Re: Clarification

I have looked at all the SL's for New Horizons Permit C-1981-008 and get confused. I would like for you to clarify.

Modified Pond 007 Drainage Area (Surface Water Features and Control)

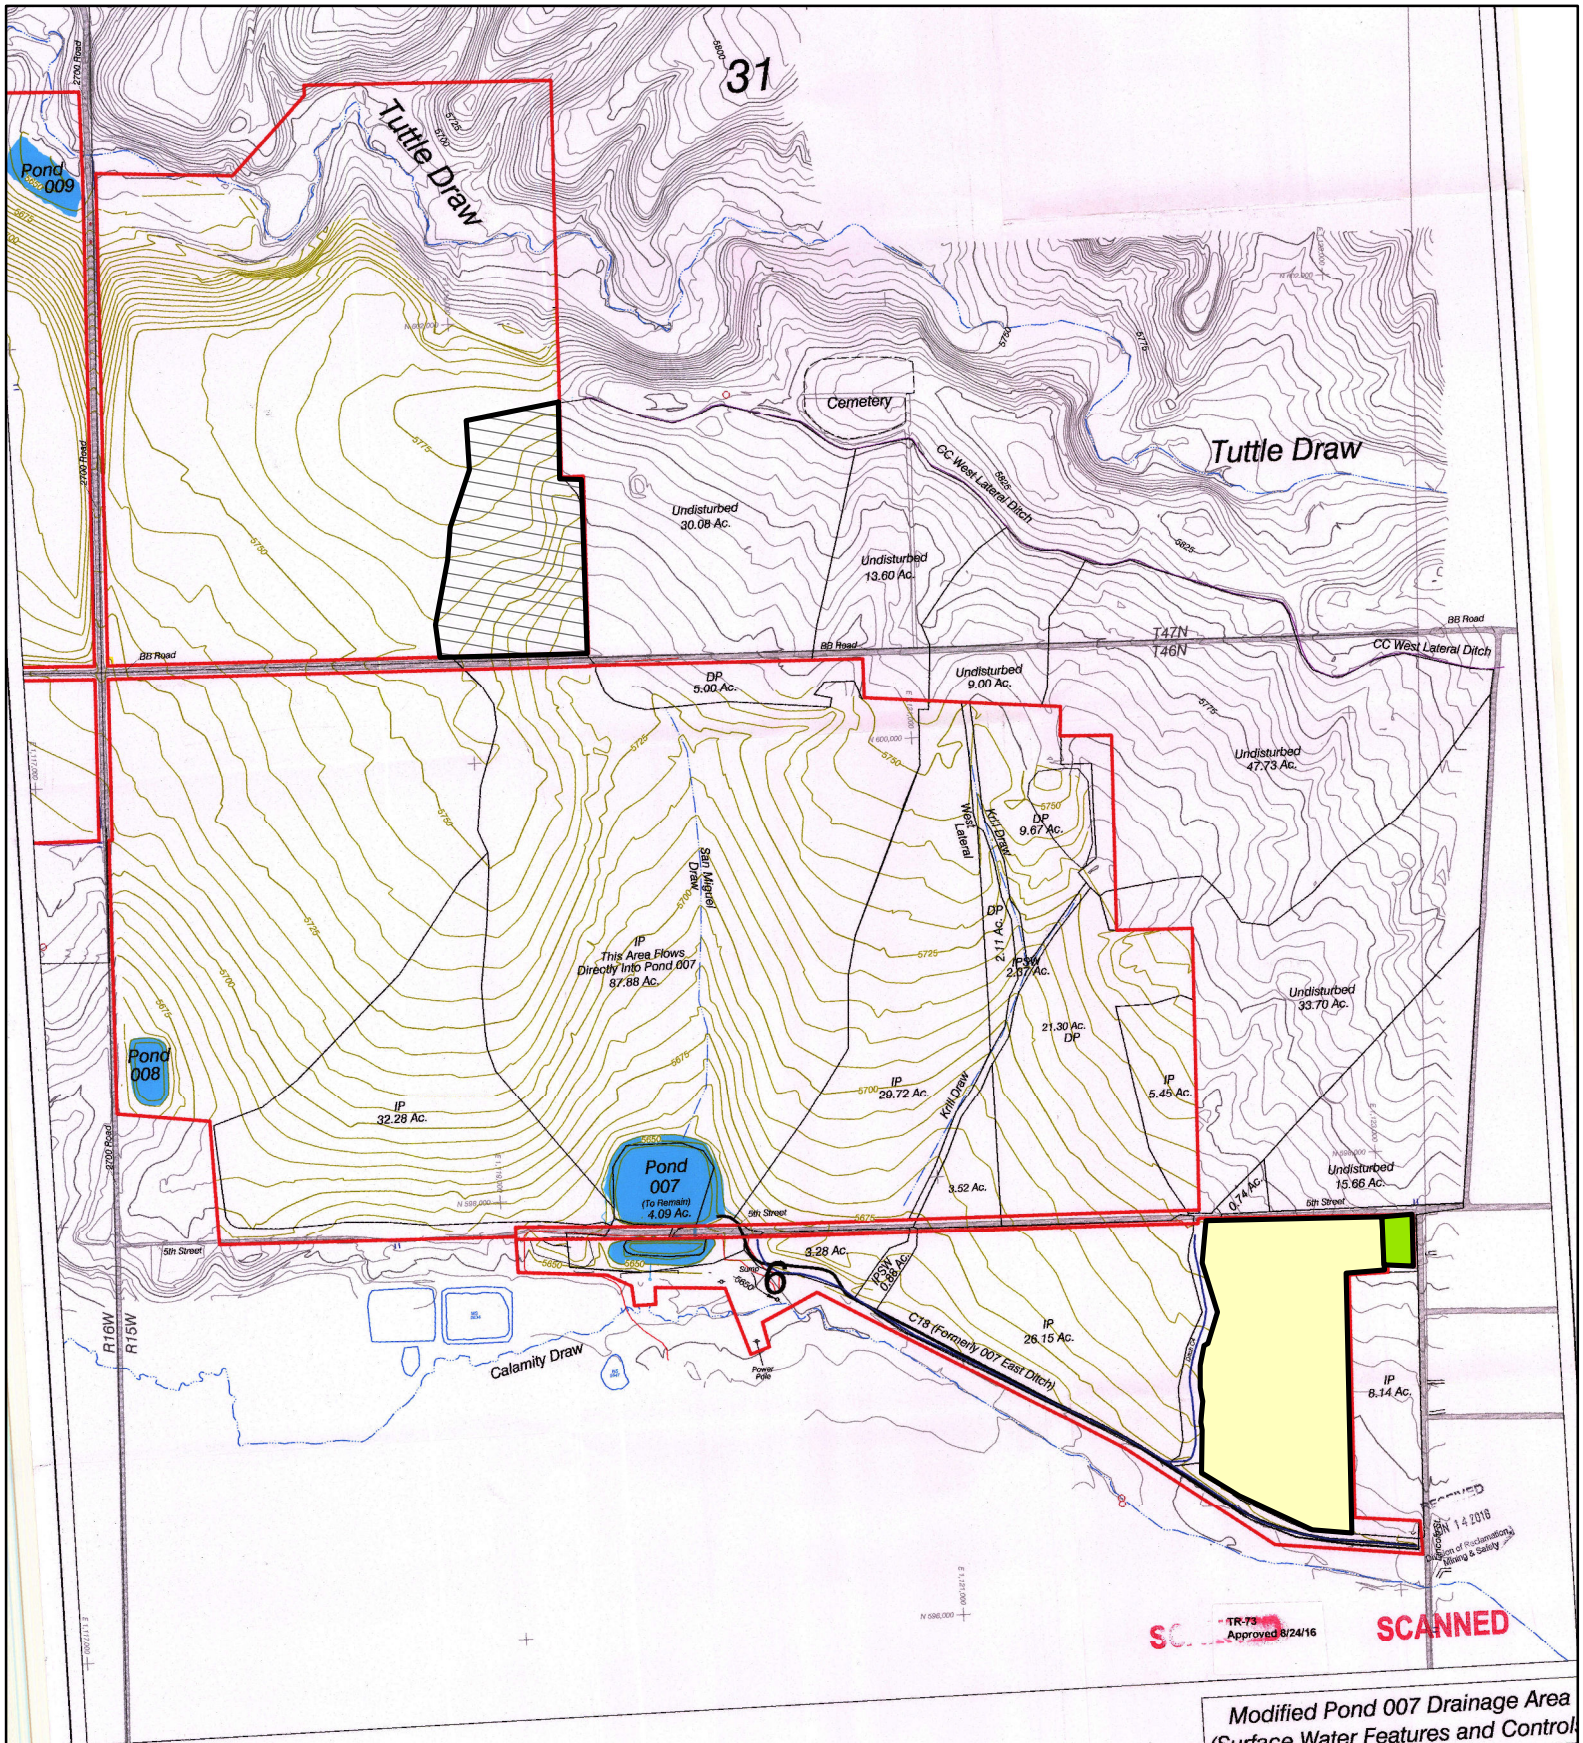
The area outlined in black on the attached map also drains to Pond 7. The topographical lines show that the land slopes to the southeast. The runoff is directed to a roadside ditch, through culverts under the BB Road and into the San Miguel Draw. These ditches and culverts were once part of the permit but have been released to Montrose County Road and Bridge. The area outlined in black received Phase II bond release in SL-11 and SL-15 and is no longer required to be treated by Pond 7 but still needs to receive Phase III bond release.

The yellow and green shaded areas on the attached map lies within the area you outlined in Purple and within the permit boundary. Both of these areas have not received Phase III. The drainage from the yellow area is directed to Pond 18 and the green area is an SAE that does not need to be treated by a pond. The attached map was used because it shows the current permit boundary.

Ditch C-18 is supposed to be reclaimed as it is no longer needed for sediment control.
